FORD:

2000-2003 E-Series, Excursion,
F-Super Duty

This article supersedes TSB **04-22-8** to update Figure 1.

TSB 04-25-4 (Continued)

Figure 1 - Article 04-25-4

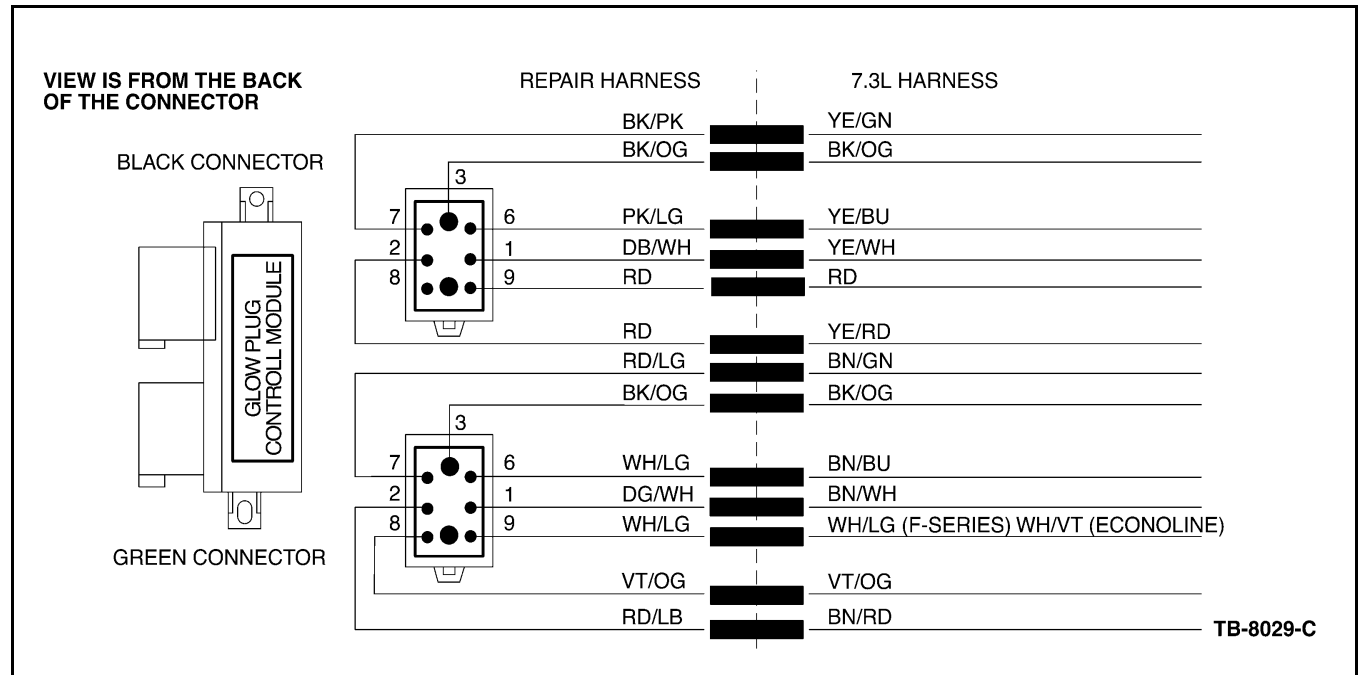
- a. If a concern is found, replace the GPCM connector with the kit. The kit contains a replacement connector with pigtail to be spliced into the existing harness. **DISREGARD THE INSTRUCTIONS INCLUDED IN THE KIT (WHICH ONLY APPLY TO 6.0L) AND REFER TO FIGURE 1 FOR WIRE SPLICING.**
- b. If no concerns are present, proceed with normal diagnosis.
